Carolina Power & Light Company
PO Box 10429
Southport NC 28461

May 13, 1994

SERIAL: BSEP 94-0179
10 CFR 50.54(f)

BRUNSWICK STEAM ELECTRIC PLANT, UNIT NOS. 1 AND 2
DOCKET NOS. 50-325 & 50-324/LICENSE NOS. DPR-71 & DPR-62
RESPONSE TO REQUEST FOR ADDITIONAL INFORMATION REGARDING GENERIC LETTER 92-01,
"REACTOR VESSEL STRUCTURAL INTEGRITY, 10 CFR 50.54(f)" - REVISION 1

Figure 4-5: Brunswick 1 Irradiated HAZ Metal Impact Energy

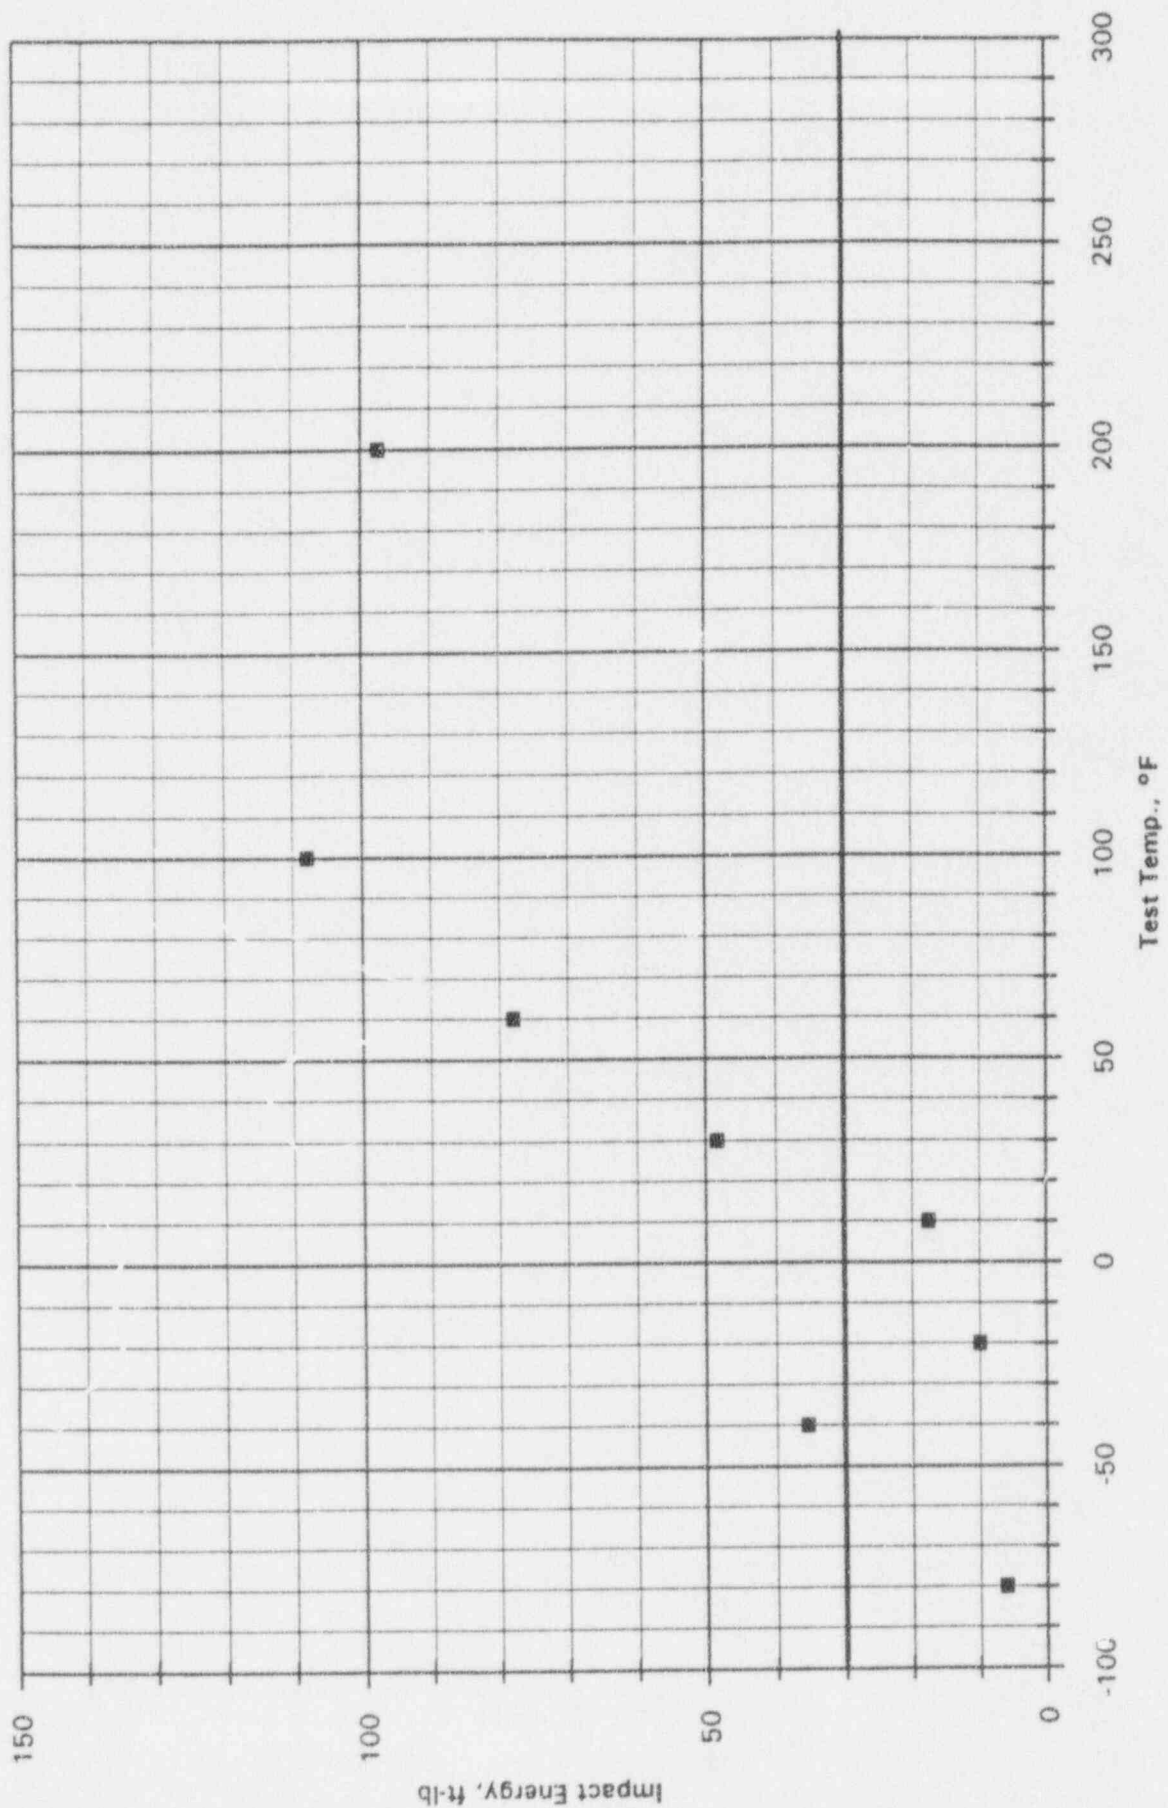
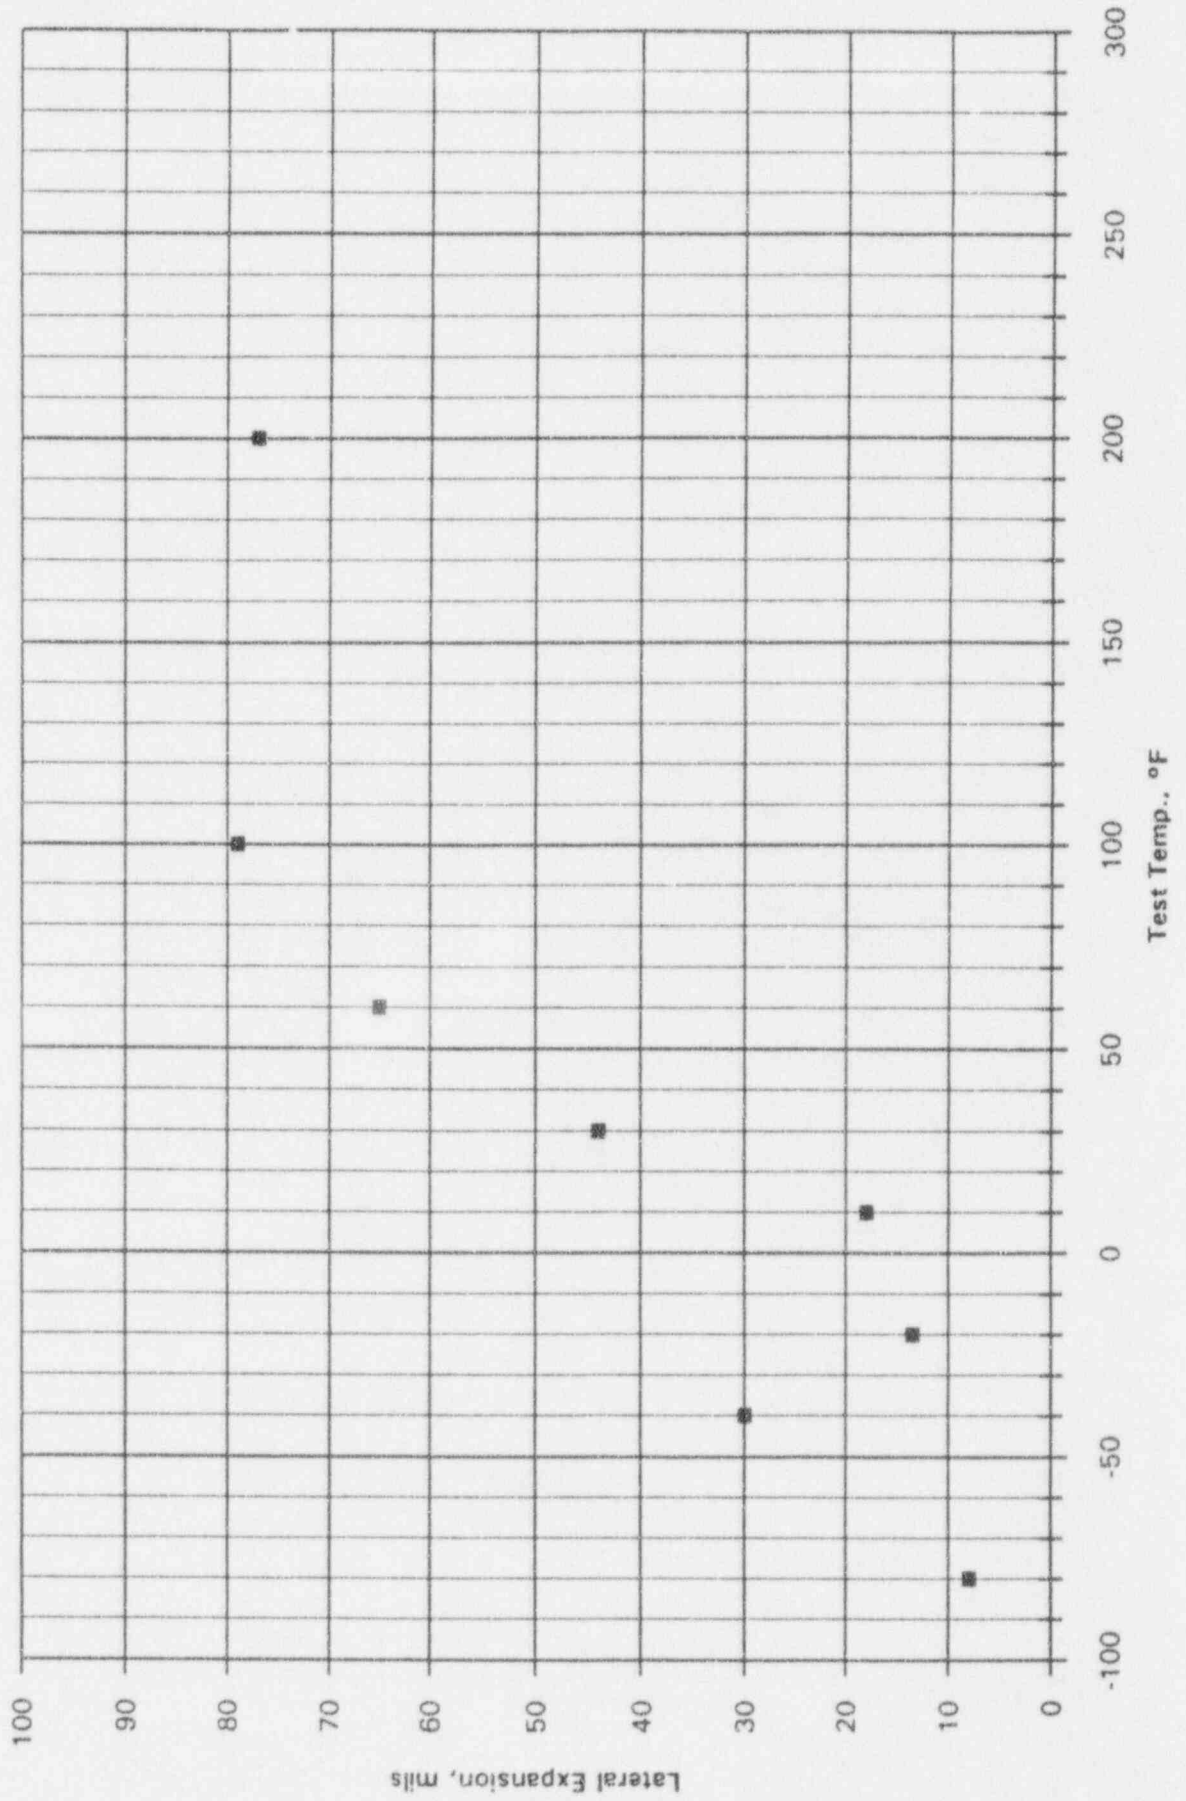
Surveillance tests have only recently been completed for Unit 1 at 8.7 Effective Full Power Years (EFPY); therefore, the surveillance report has not been finished (10CFR50 Appendix H report to be submitted to NRC by August 17, 1994). The Charpy curves, developed for weld and base metal (base metal Heat No. C4487-1) during these tests are attached for information (pages 12-18). Since the Unit 1 surveillance capsule dosimetry report is not complete, unverified dosimetry results have been used to make small changes in the fast neutron values used in the attached Appendix B pages (pages 8-11).
